DEVELOPMENT HEARING OFFICER
SUPPLEMENTAL SUBMITTAL

PROJECT NO. PR-2022-007299
Application No. SD-2024-00113

Re: Prelim / Final Plat Review for Proposed Subdivision of Tracts I-A and I-B, Coors Plaza, being comprised of Remaining Portions of Tracts I, Coors Plaza and Tracts 54 and 55, Unit 6, Town of Atrisco Grant

Plat for Tracts I-1 and I-2, Coors Plaza Being Comprised of Remaining Portions of Tract I, Coors Plaza, and Tracts 54 and 55, Unit 6, Town of Atrisco Grant City of Albuquerque, Bernalillo County, New Mexico May 2023

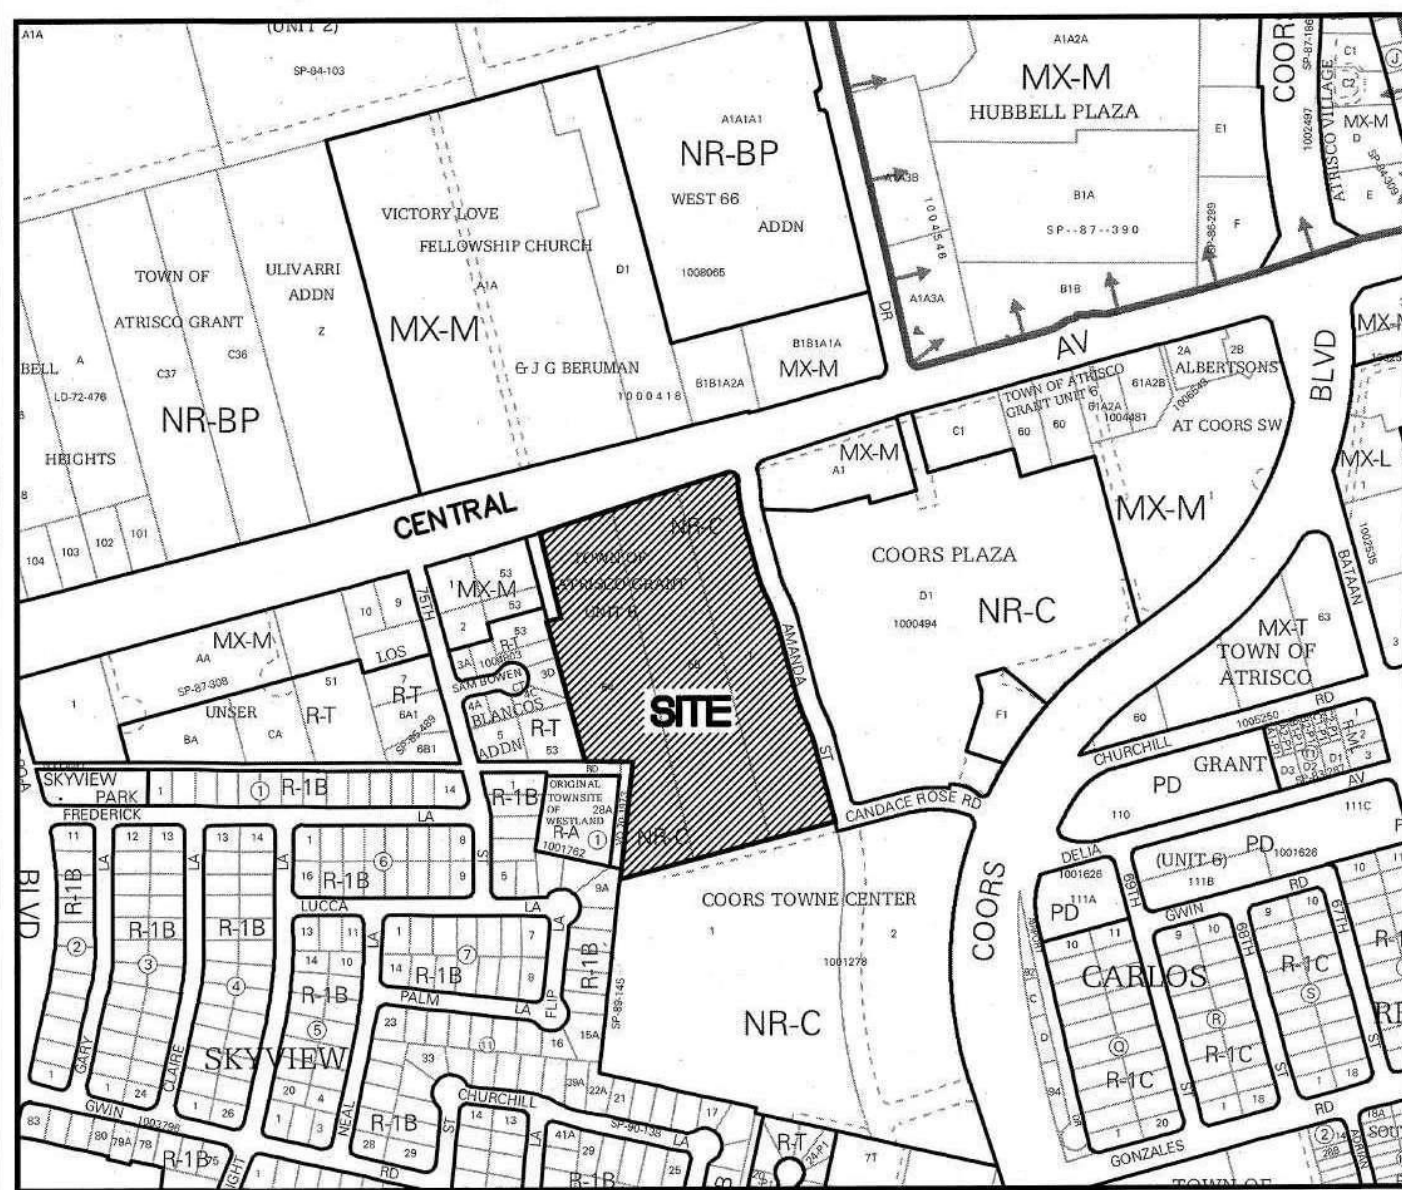
• The applicant is currently in the process of submitting a site plan for the subject property and will be tying in the infrastructure list with the site plan and not the plat. Confirm if any portion of the infrastructure list will be outside of the boundary lines shown on the upcoming site plan.

Site plan shows the full extent of the platted parcels we look to replat.

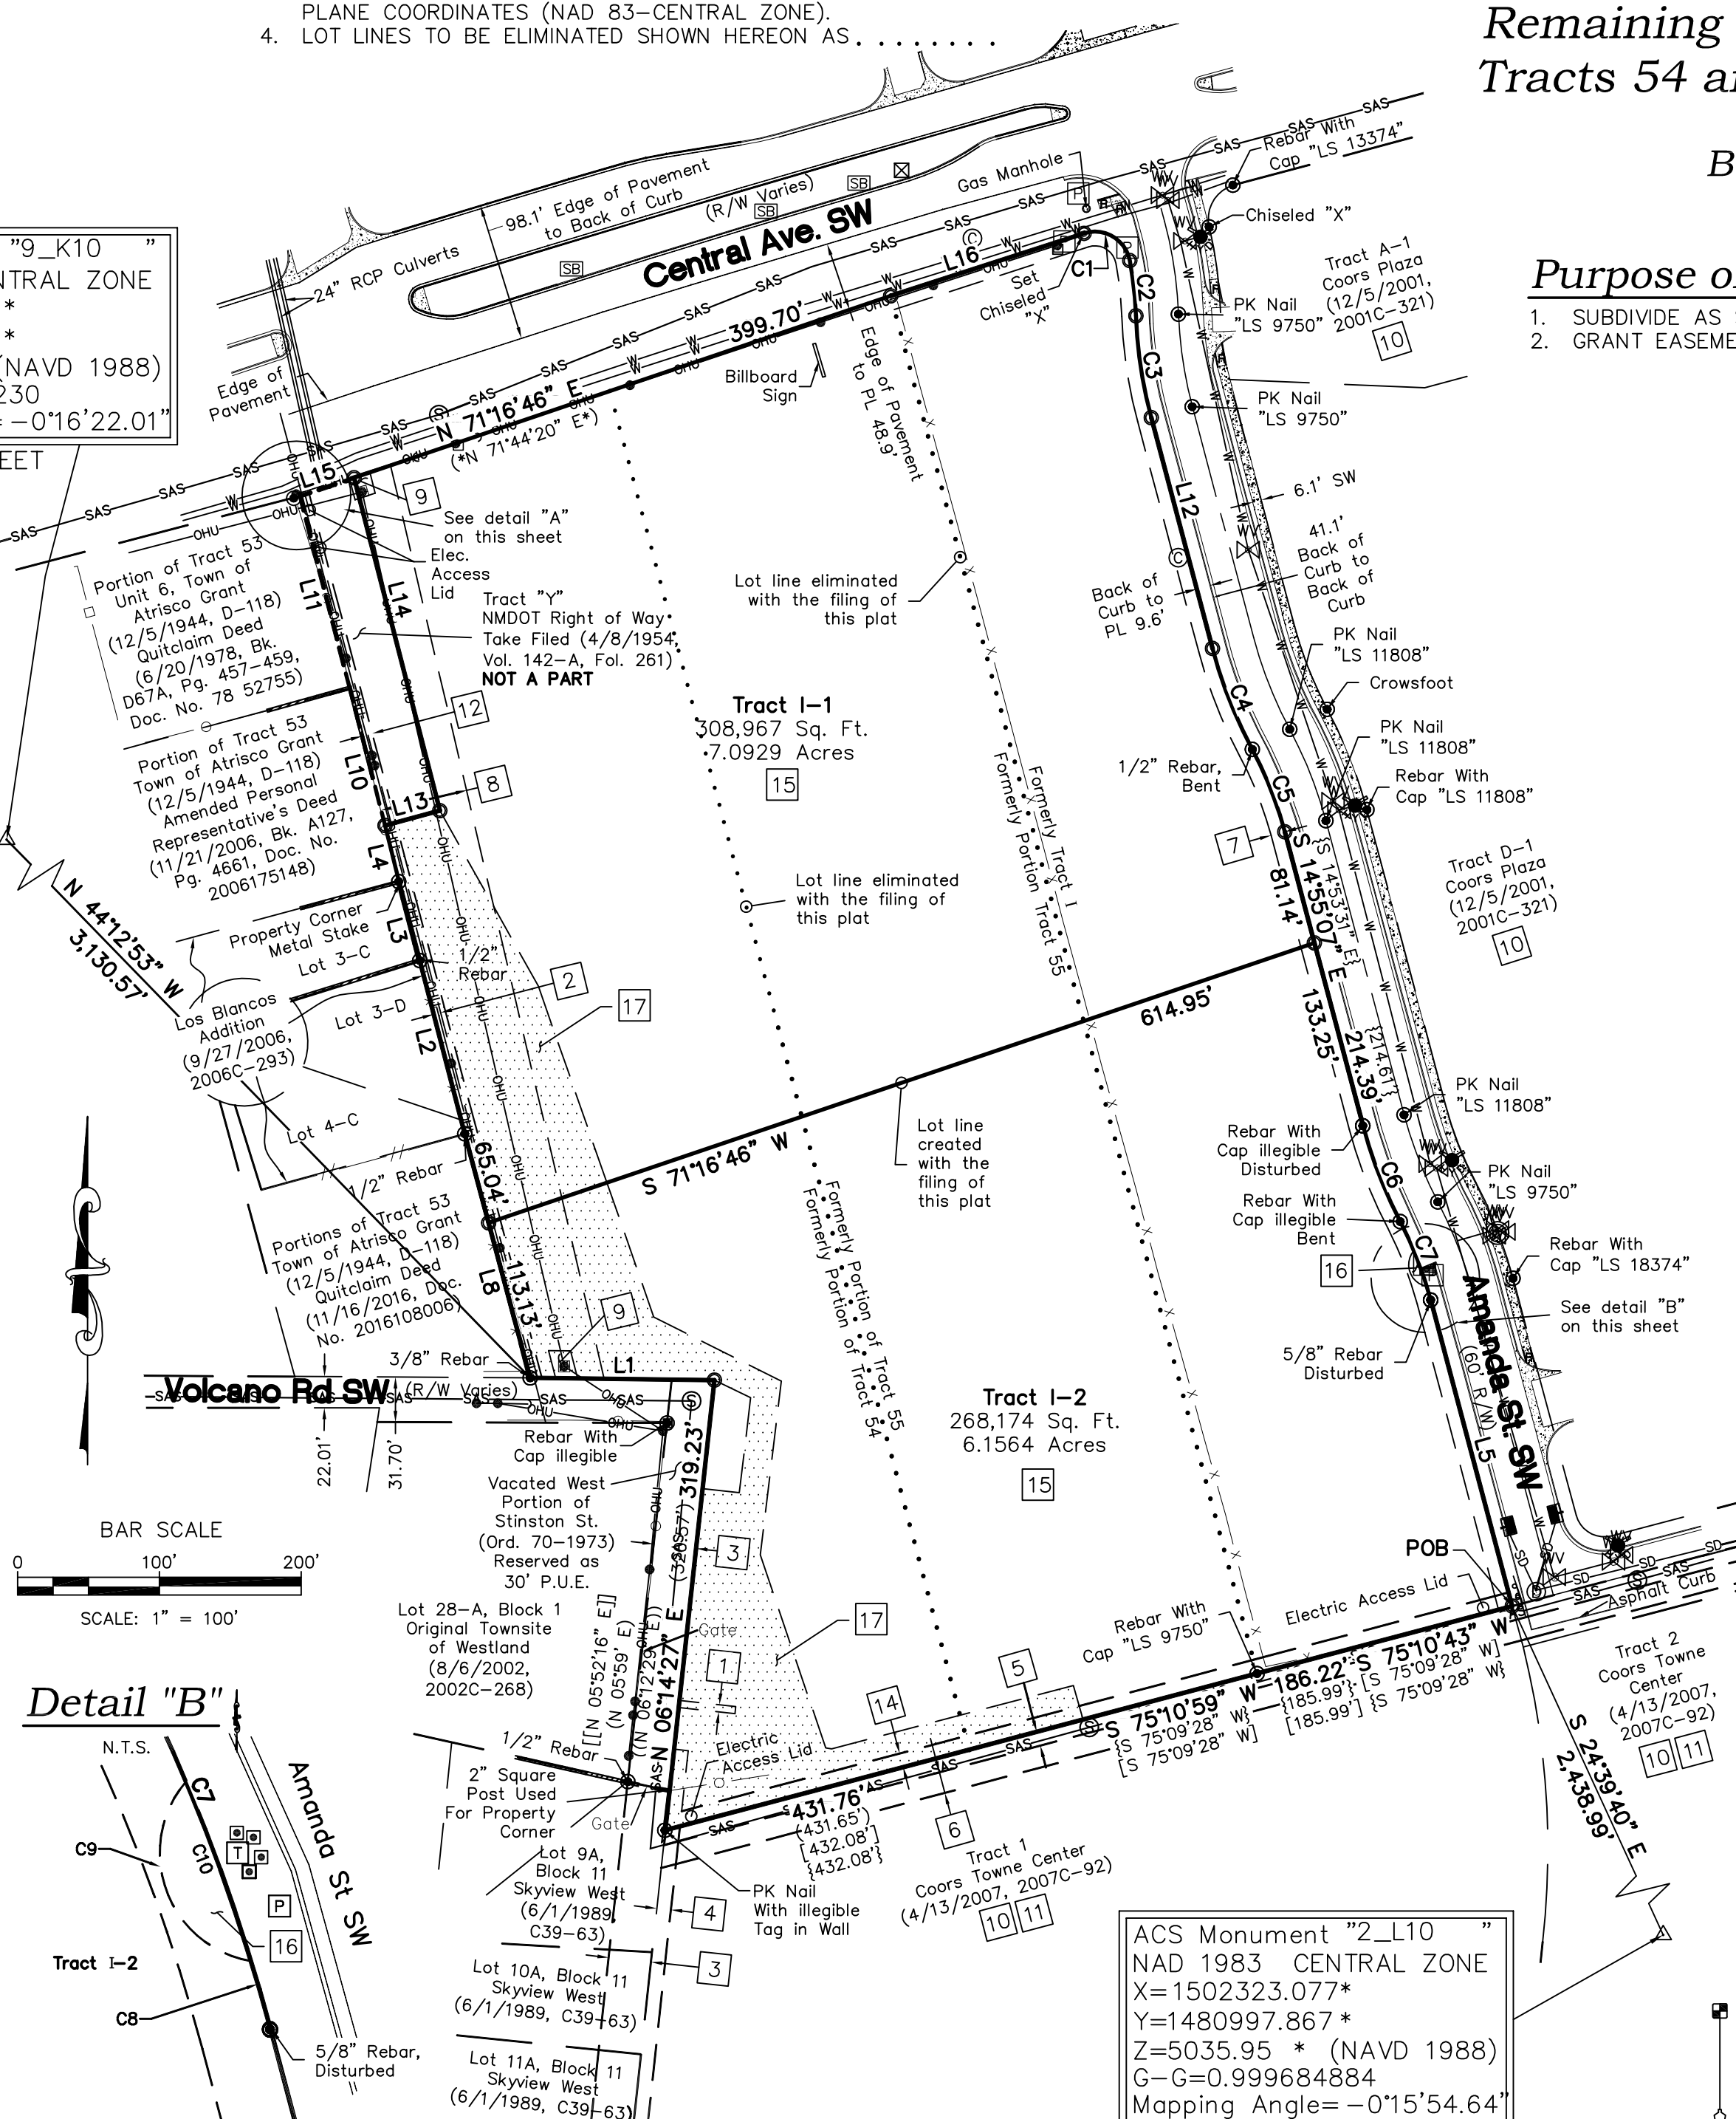
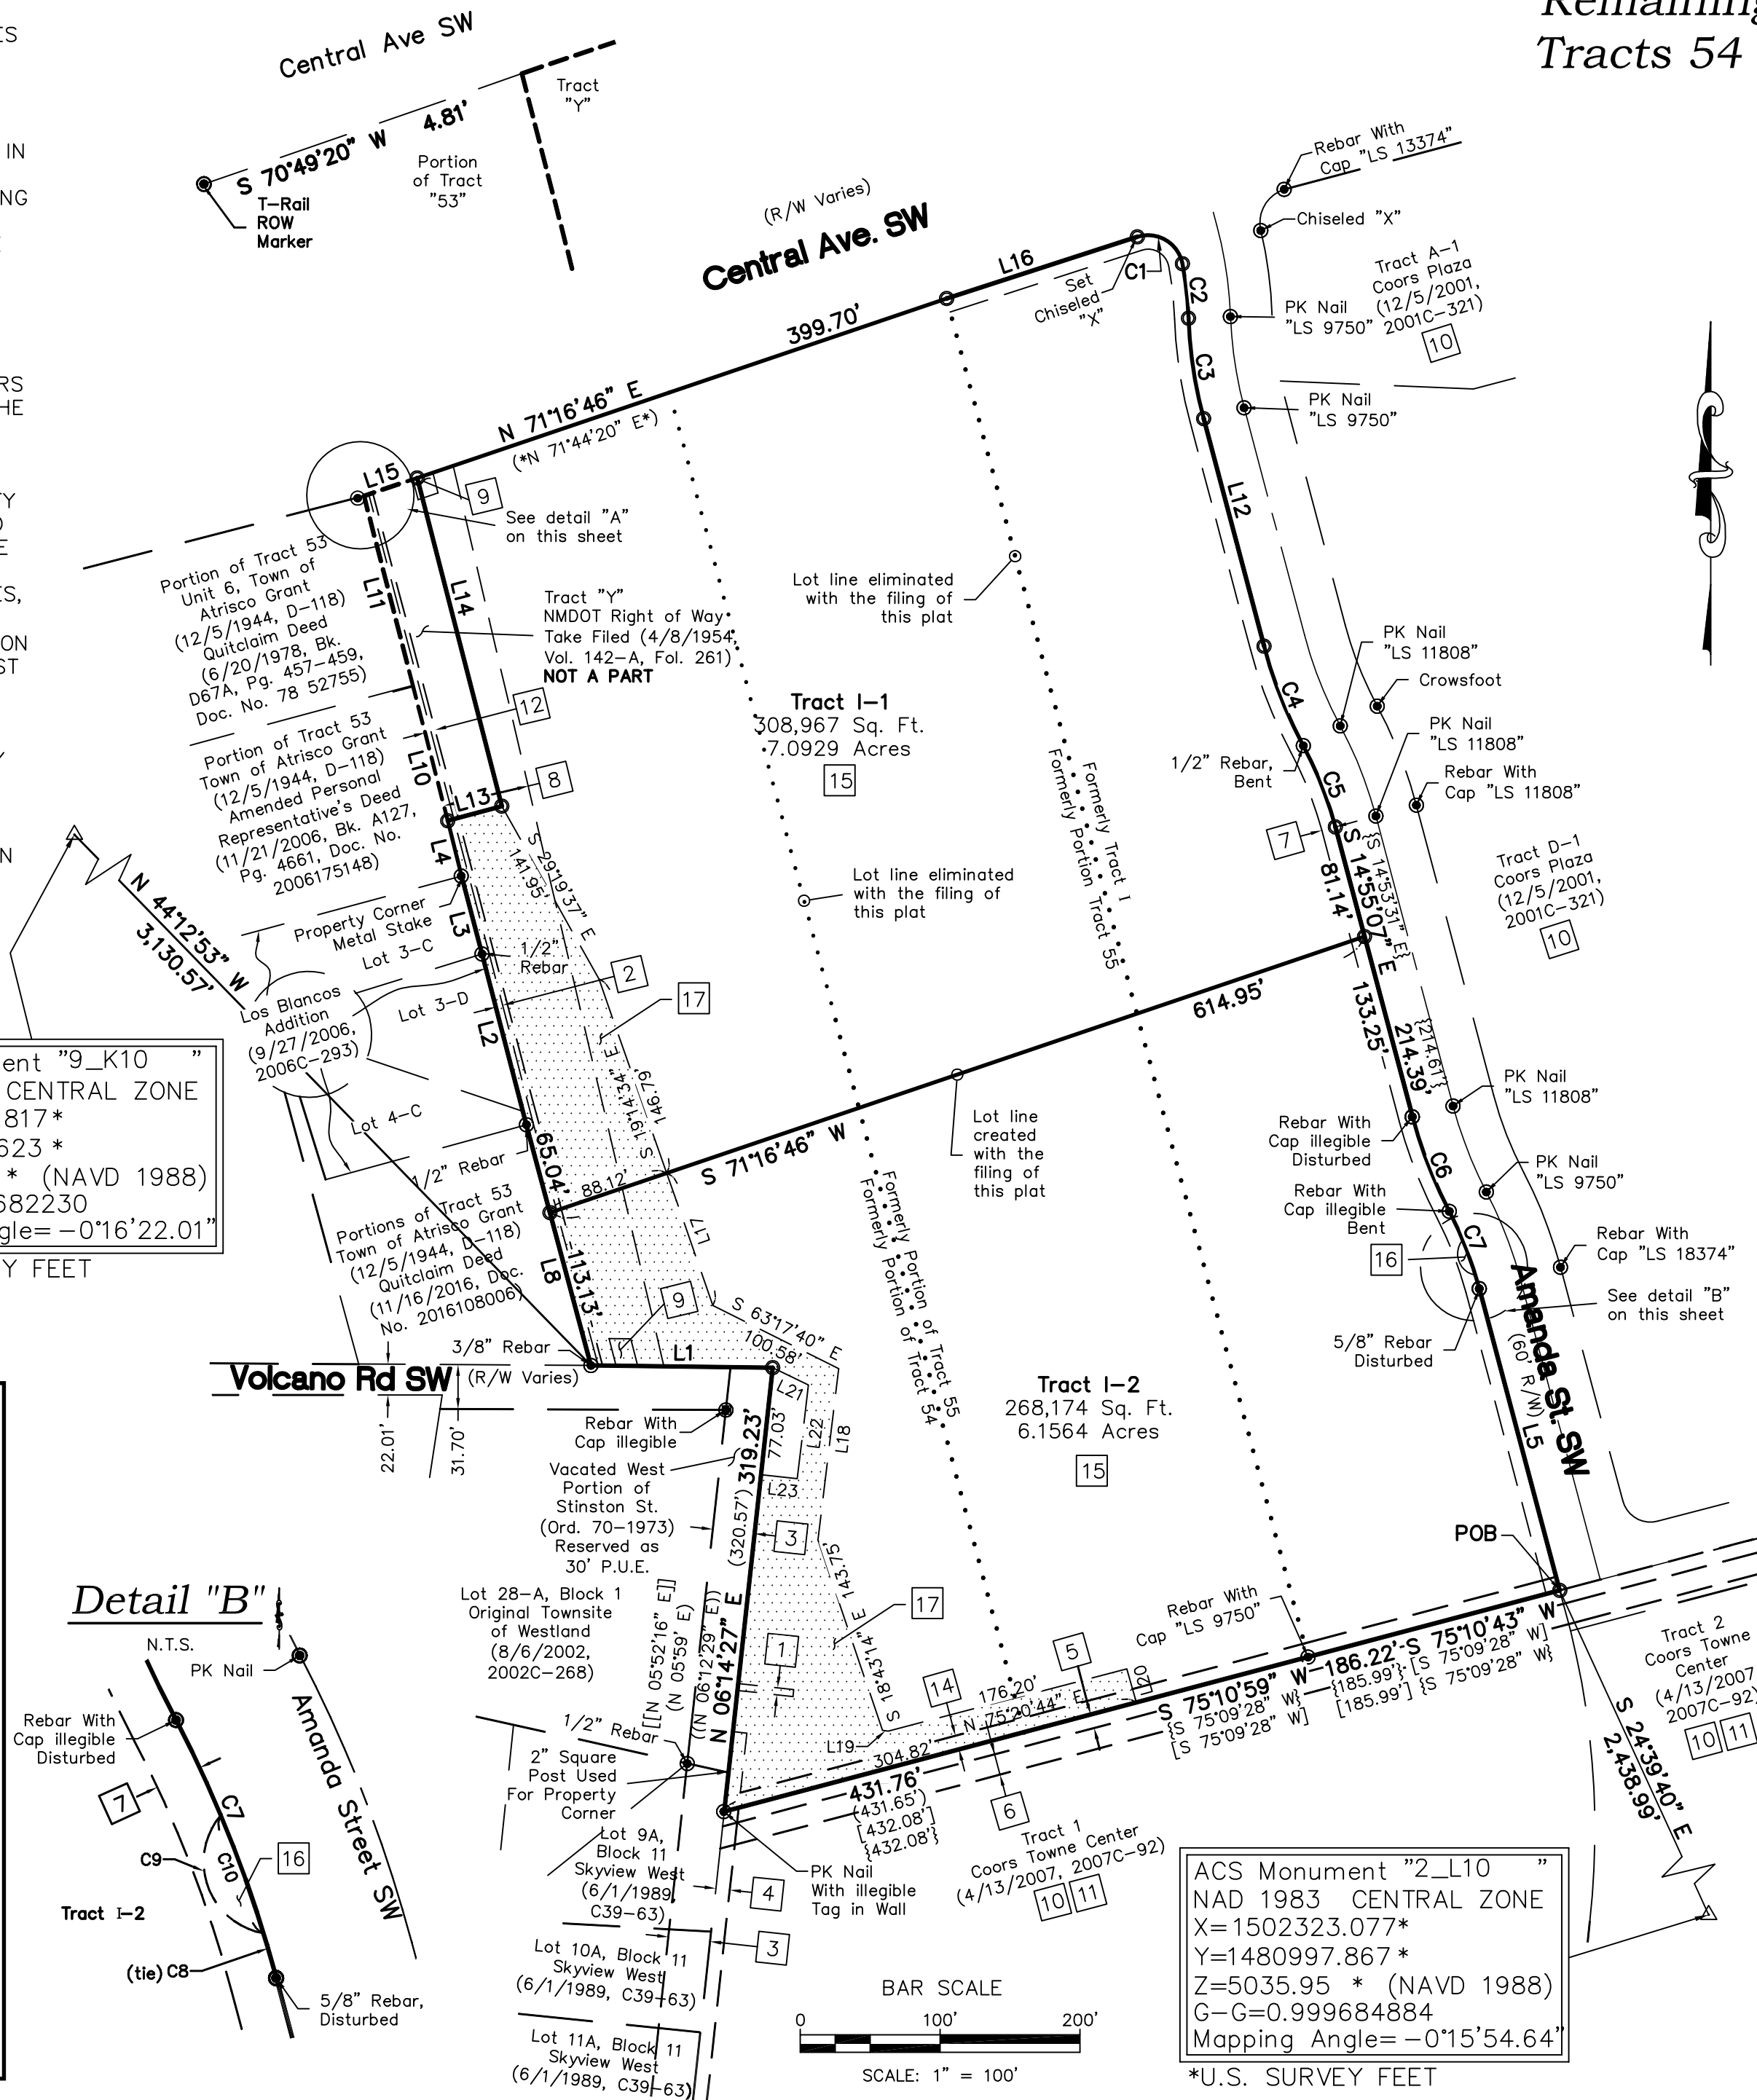
3. Please clearly identify the purpose of easement note 3 and its applicability for public water and sewer to remain within this corridor. If this is not clear, please grant a public water and public sanitary sewer easement for this infrastructure if within this property. It is not clear if this portion is part of the platted area.

- Hydrology has an approved Conceptual Grading & Drainage Plan (K10D070) with engineer's stamp 06/06/2024.
- Hydrology needs a Public Drainage Easement as shown since there is public drainage passing through this sit
- Please add the City's standard drainage easement language.

Easement [3] is an off-site easement for a former portion of right-of-way, which was retained as a public utility easement and contains an existing 12” concrete sewer line

Noted, easement for public drainage is provided under note [17].

Detail "B"

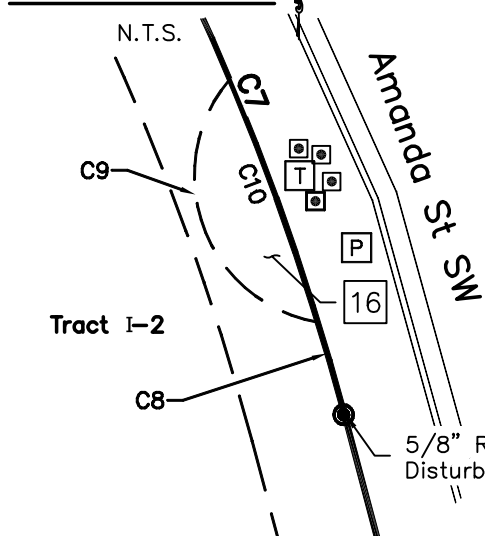
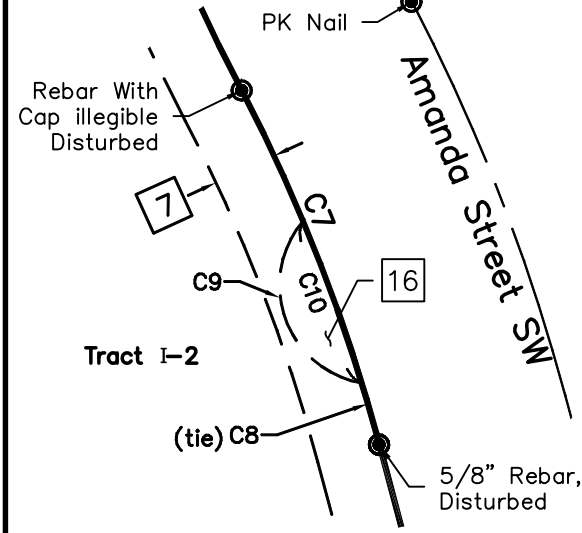
1. Central is a Principal Arterial within a center and requires 10' sidewalk with a 6' to 8' landscape buffer. Amanda St. is a local road and requires 5' sidewalk and a 4' to 6' landscape buffer. All sidewalks must have a 4-foot ADA pathway around all obstructions within right-of-way. ROW appears to be adequate along both roadways.
2. All work within the ROW shall be done under a work order and all infrastructure items placed on an infrastructure list.

Noted, Infrastructure list attached for proposed sidewalk along Amanda Street and the asphalt trail extension along Central Ave SW are provided and should be tied to parallel site plan

application. Pathway around obstructions is addressed with new easement [16] along Amanada Street SW.
